STATE OF MAINE
DEPARTMENT OF TRANSPORTATION
16 STATE HOUSE STATION
AUGUSTA, MAINE 04333-0016

September 8, 2014
Subject: **Durham & Lisbon**
State WIN: 018239.00 &
018382.00
Amendment No. 4

Make the following changes to the Bid documents:

CHANNEL-SECTION RUB RAIL AND SPLICE

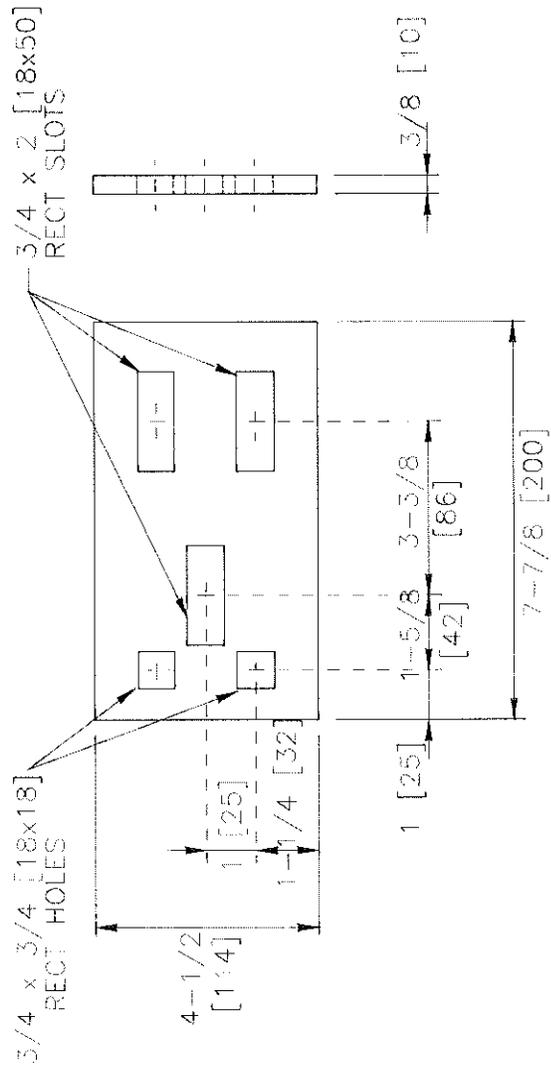
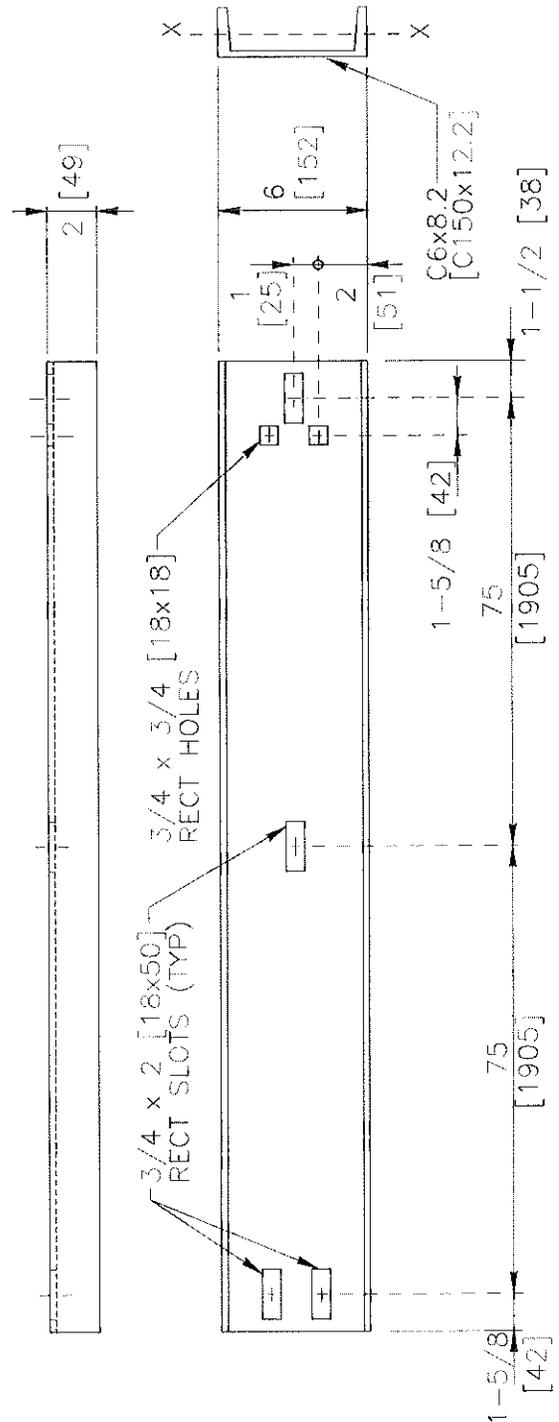
Question: Do you have any details for Item # 606.551 GR type 3 – Single Rail with Rub Rail?

Response: The rub rail material, installation, and attachment shall be as per the guardrail manufacturer's recommendations, and shall meet MaineDOT specifications for Guardrail Type 3C – Single Rail and the attached standard AASHTO details RLR01 and SGM06a-b. The SGM06a-b shows a median barrier application; apply the mounting height of rub rail and connection details to the Type 3C guardrail. Be aware that Item 606.551 GR Type 3 – Single Rail with Rub Rail contains guardrail on a radius.
